New FC Endwall Tools and Assembly Tests

- Profile bending tool
- Comments/feedback on preliminary FC endwall design
- Suggestions of alternate components/features

New FC Endwall Design (Preliminary)

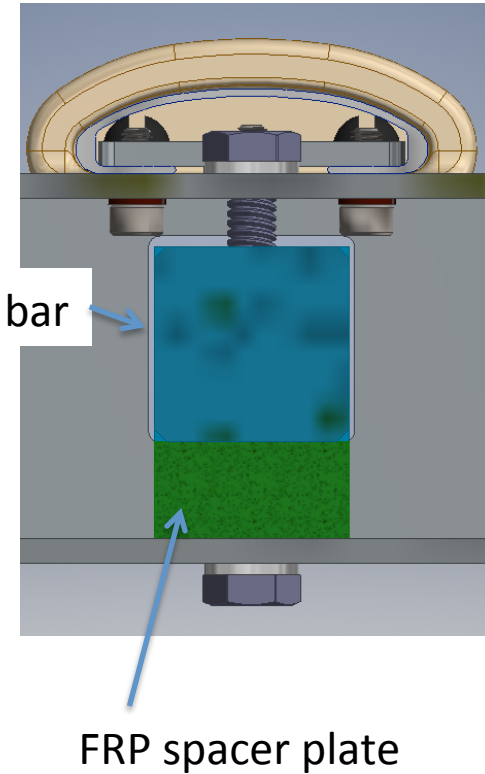
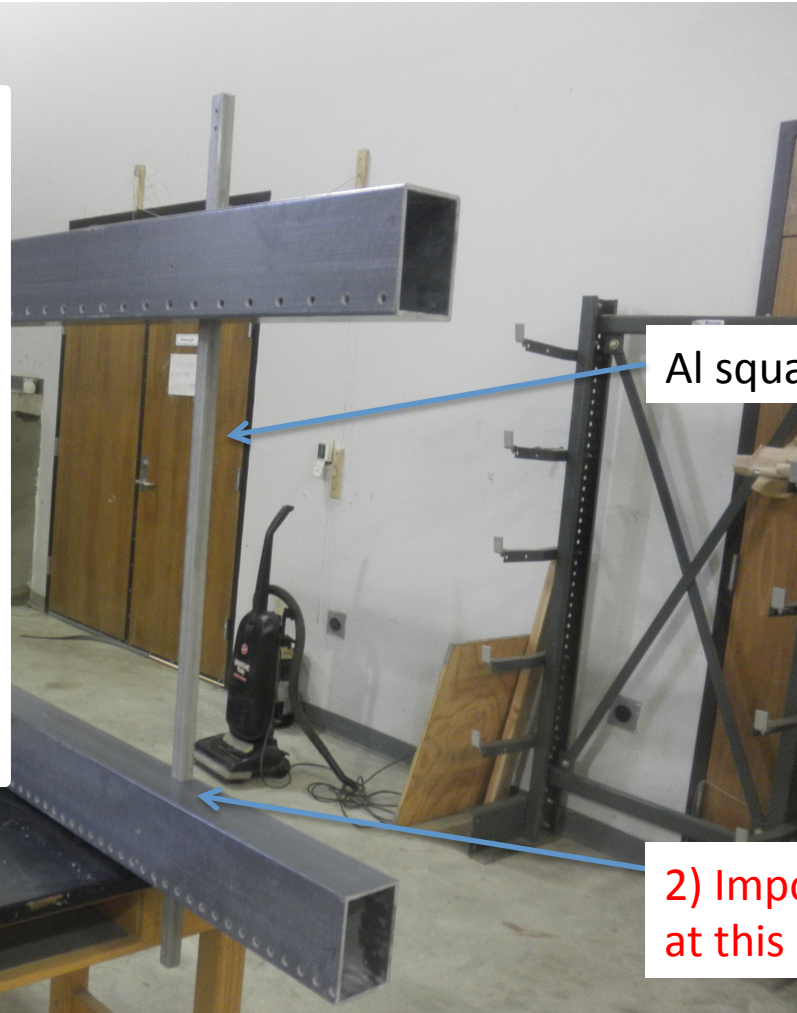
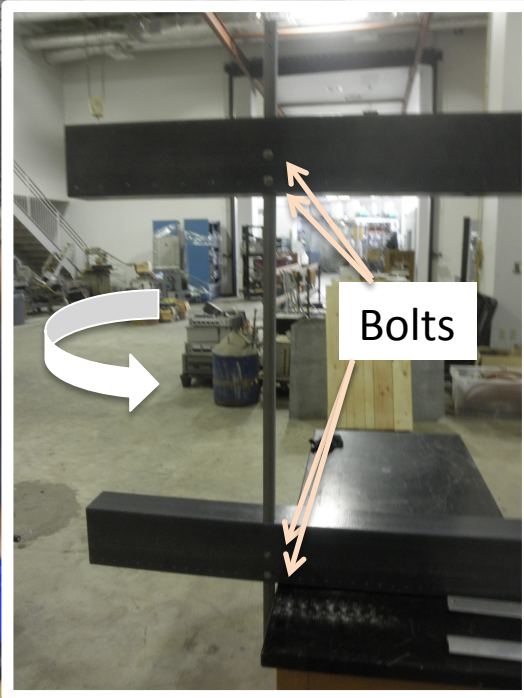
Used washers instead of FRP spacer plate

1) Recommend to oversize square cut outs in box beams (to facilitate assembly and FRP box beam tolerances)

2) Impossible to insert spacer plate at this location !

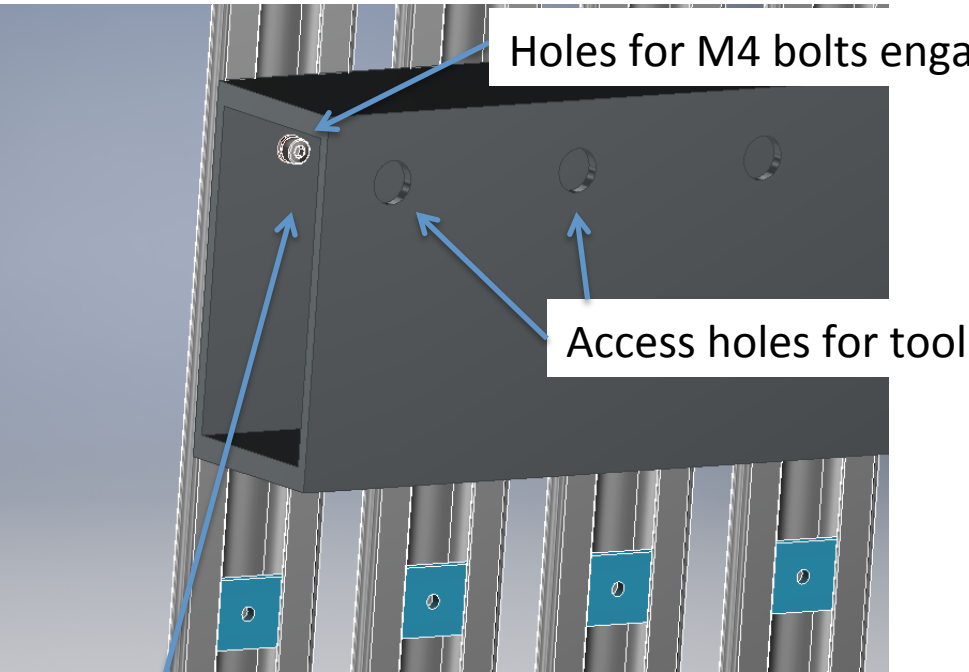
1) Recommend to oversize square cut outs in box beams (to facilitate assembly and FRP box beam tolerances)

Al Profile Mounting

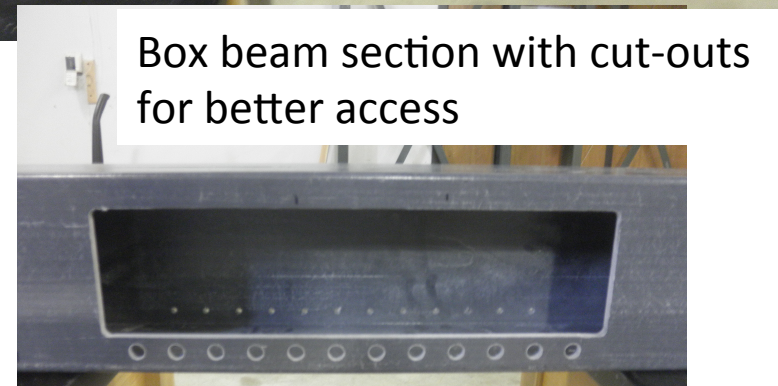
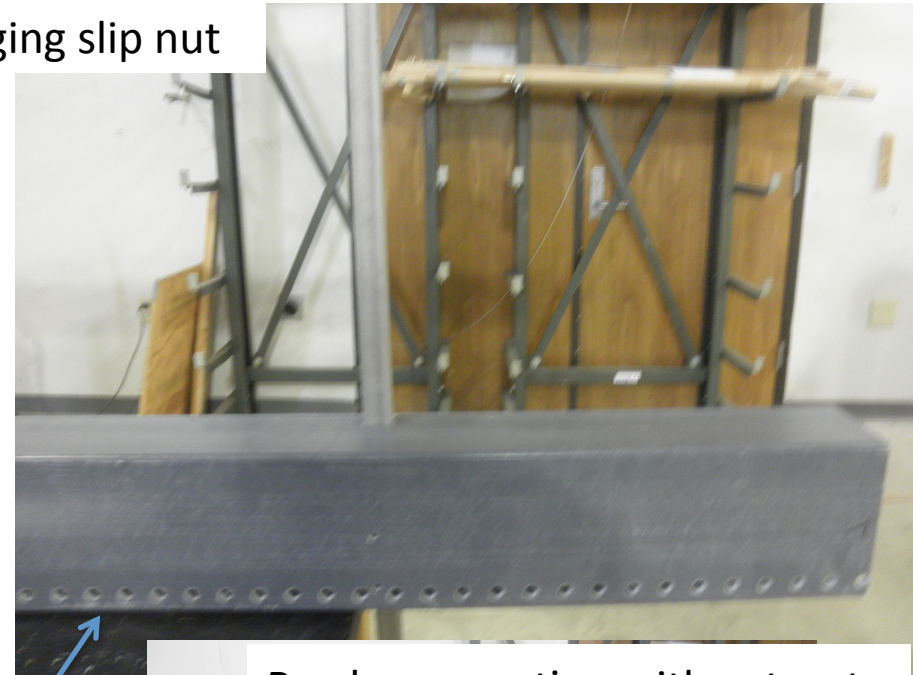
- 1st box beam for single hole slip nuts
- 2nd box beam for dual hole slip nuts

→ Mounting of Al profiles with dual hole slip nut is very cumbersome (even in easy access section of box beam)

Al Profile Mounting

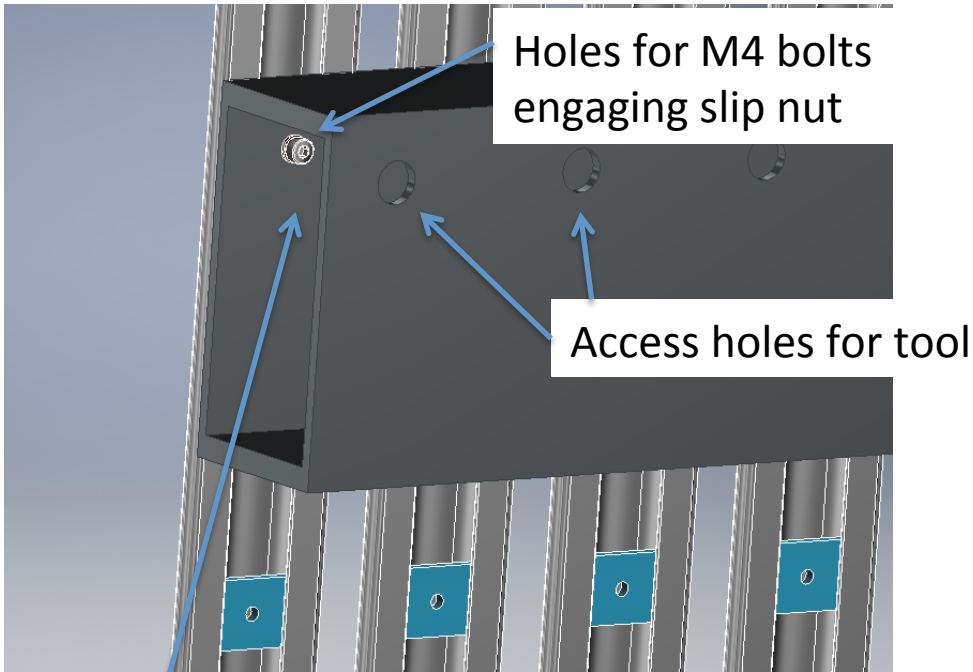
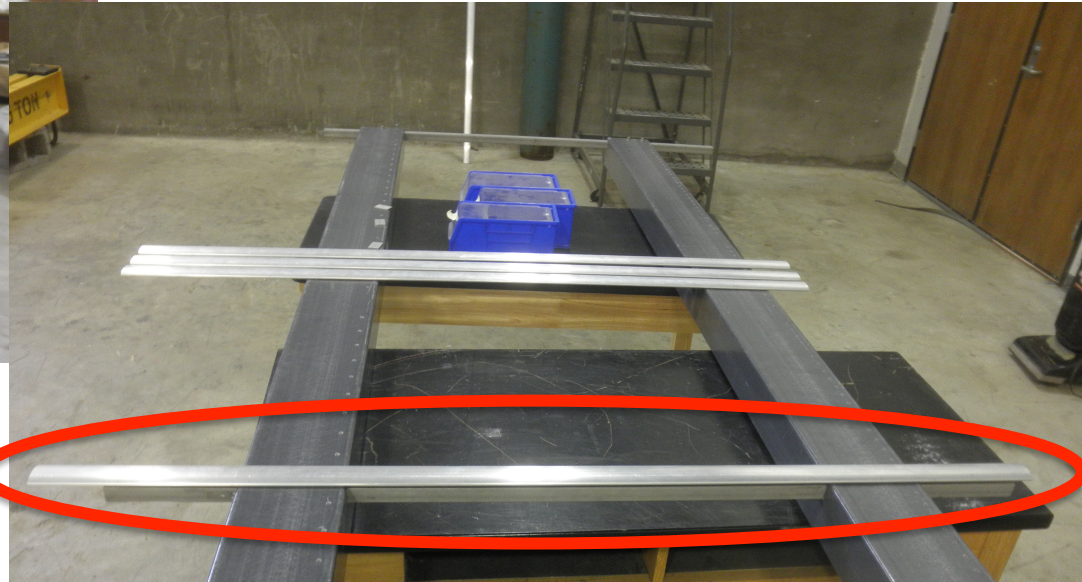
Pre-mounting of single hole slip nuts

Sliding profiles over
pre-mounted slip nuts
And tightening bolts
is straight forward

→ Could increase size of single hole slip nuts if concerned about profiles slipping⁹
